FINAL PLAT OF
WOODLAND LAKES ESTATES
AN ADDITION TO WICHITA, SEDGWICK COUNTY, KANSAS

Re: S/D 95-59 - WOODLAND LAKES ADDITION (Revised Final Plat)

STAFF REPORT

CASE NUMBER: S/D 95-59 WOODLAND LAKES ESTATES

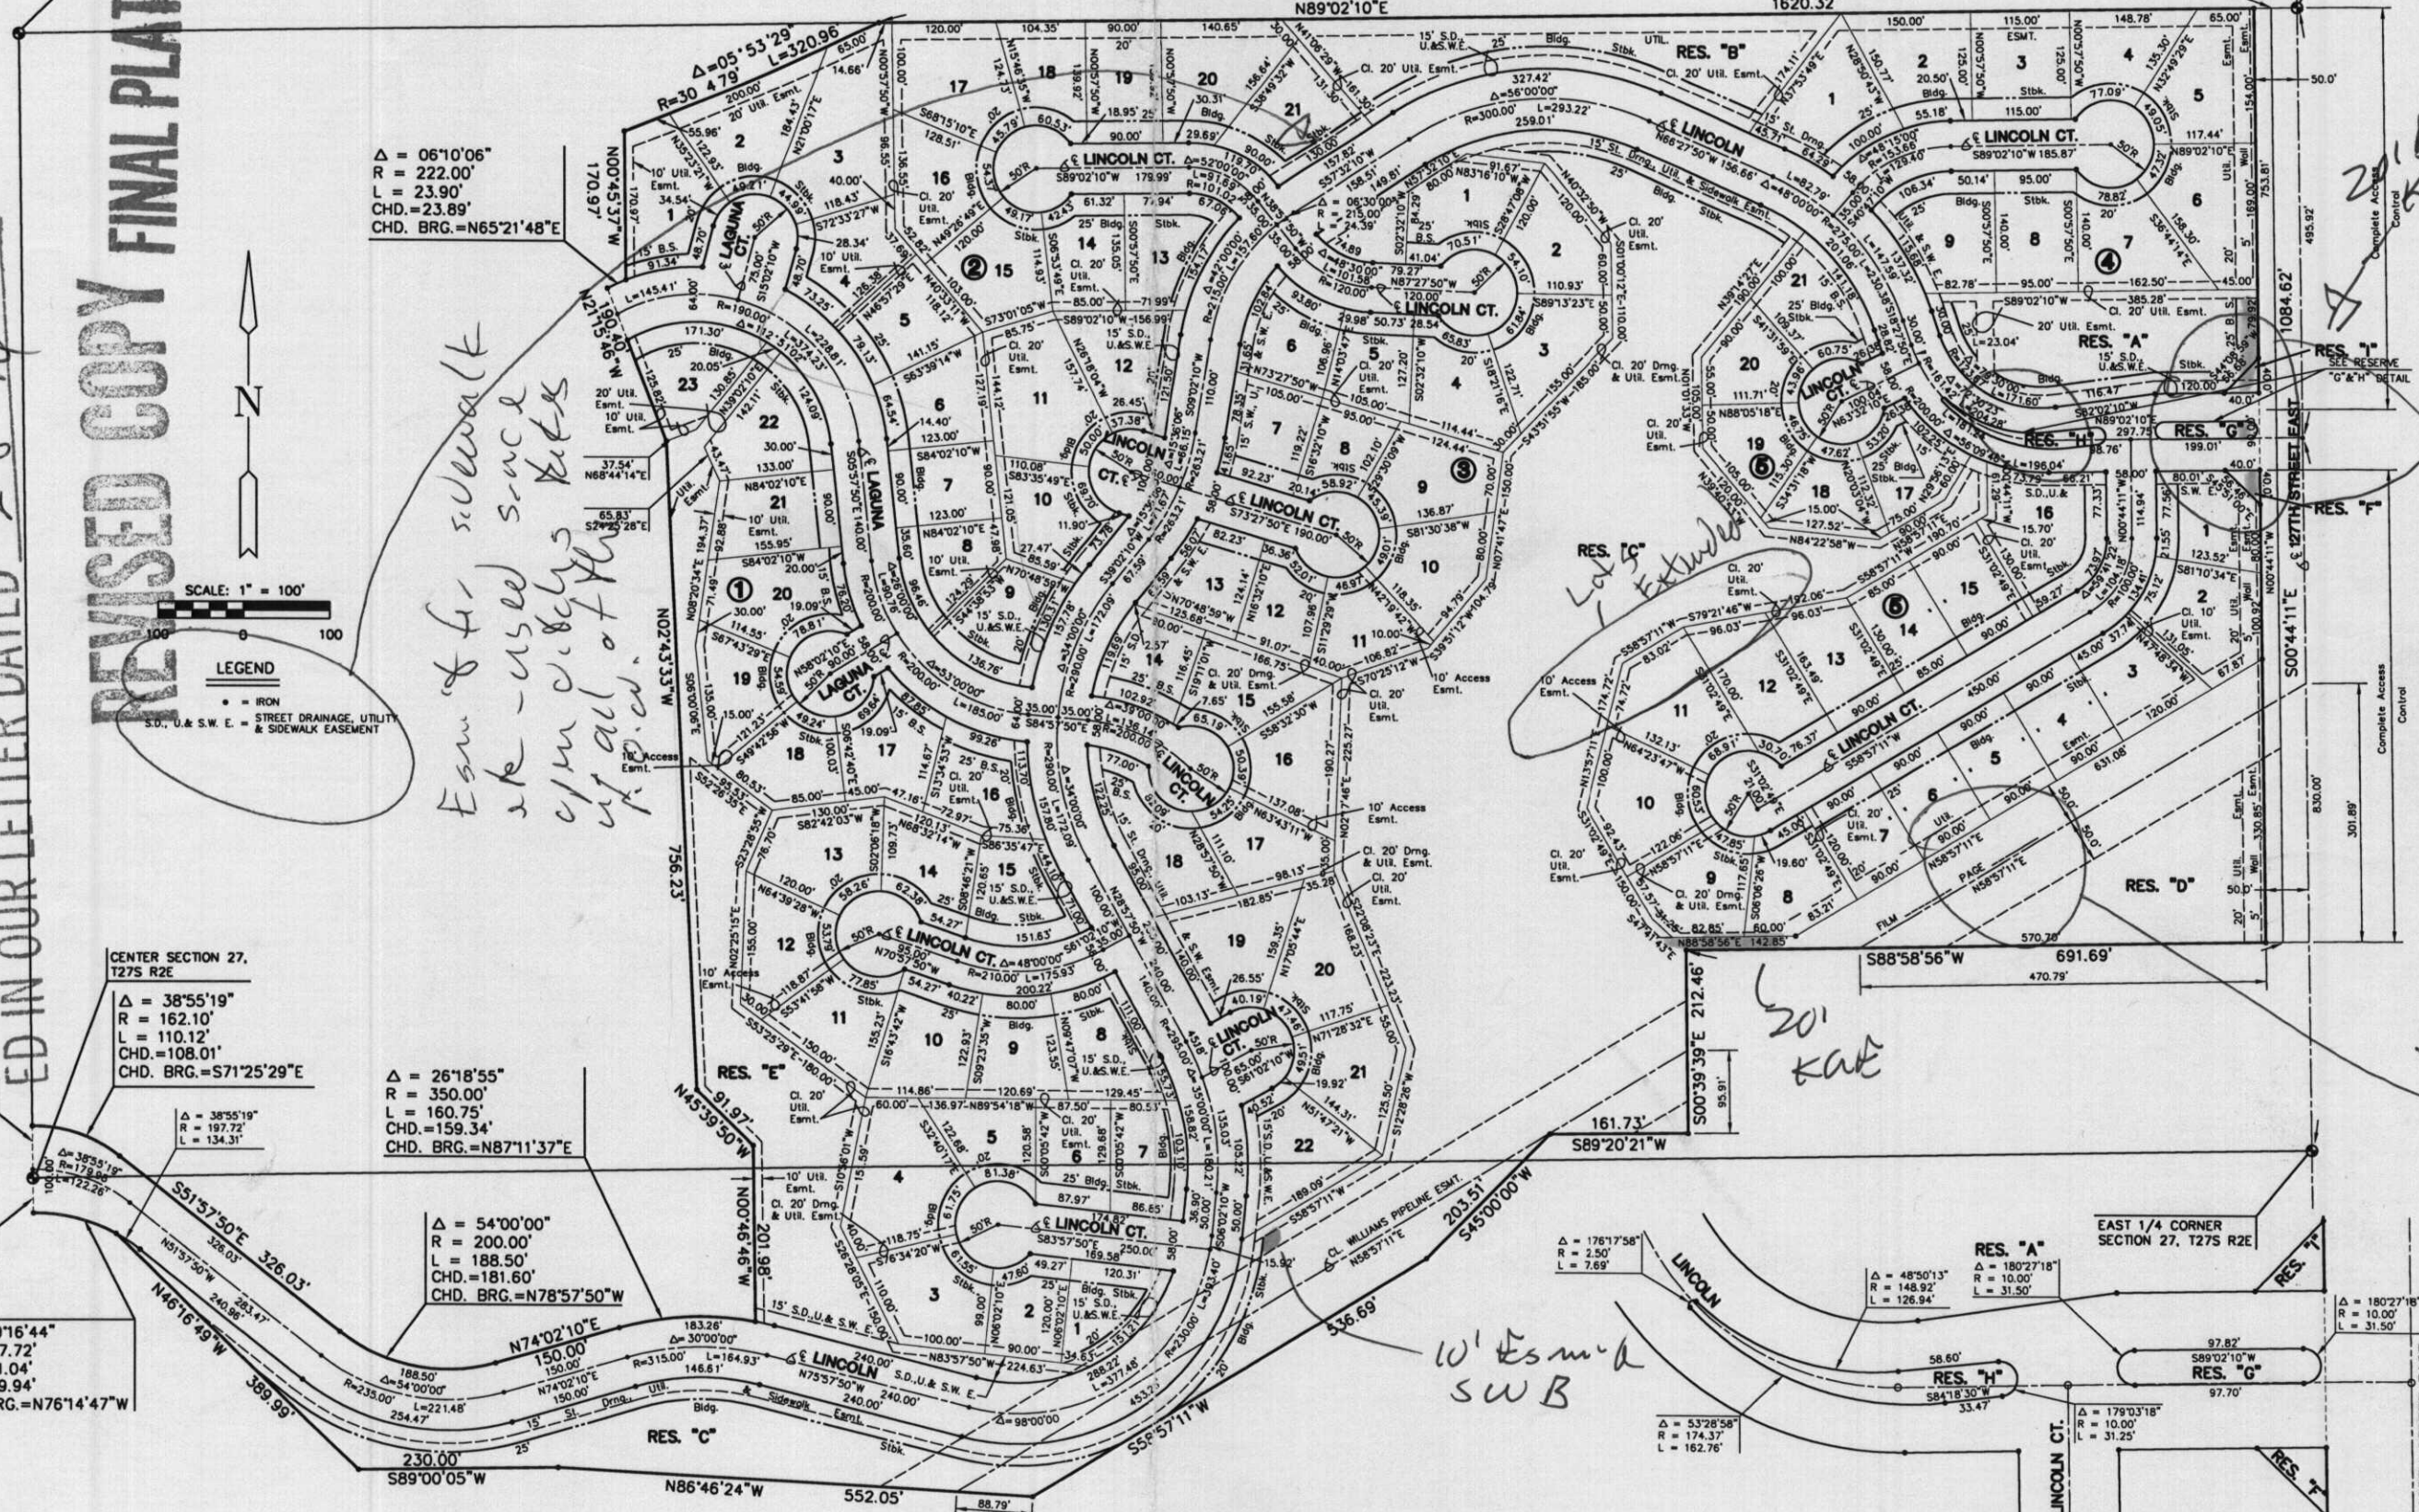
*Revised by increasing # of lots
from 88 to 96*

*Est. of for sidewalk
are used since
c/pm circles kids
at all of the
H.O.s.*

*20' Est. to
Hwy. Added
G. corner plat.
but not final - all other is a new
doc. containing
recorded & shown
HP*
